PlanGrid Task Report - Oct 9, 2024

TAB Punch List

#621 [UNIT 501] [NEW] Equipment low voltage diagrams

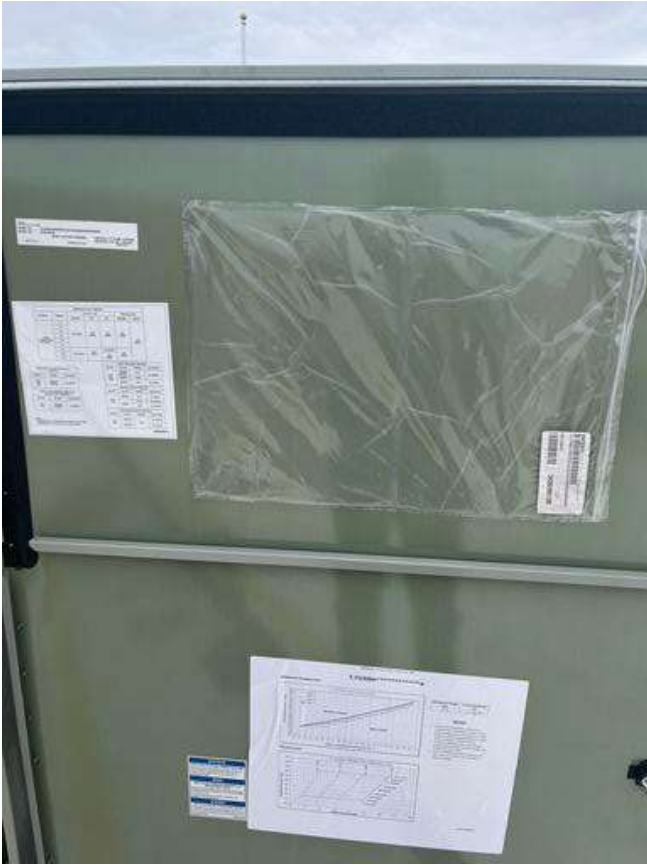
AC-1,AC-2,AC-3 missing laminated copy of controls detail low voltage wiring diagrams.

#617 [UNIT 999] [NEW] (MISC) AC Alarms

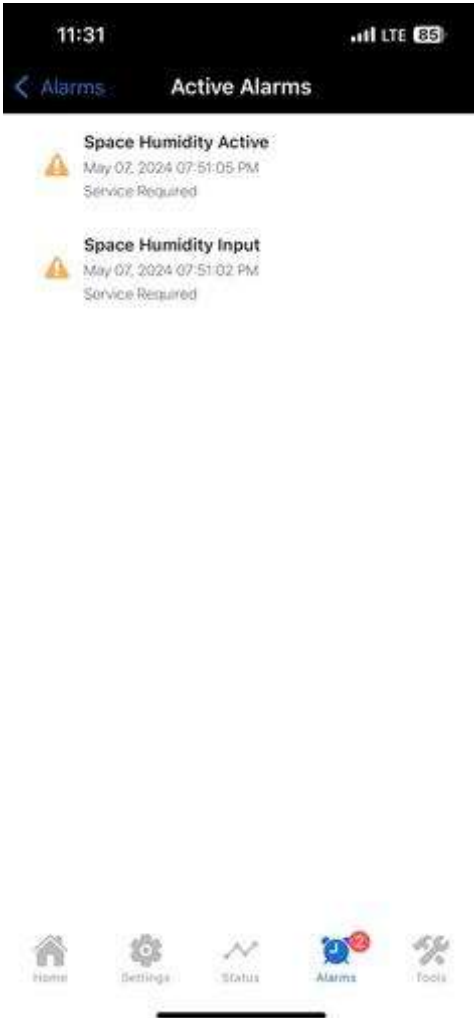
All AC units have alarms showing 1. "Space humidity active" 2. Space humidity input.

This is a Trane issue and they are scheduled to come back and fix this week.
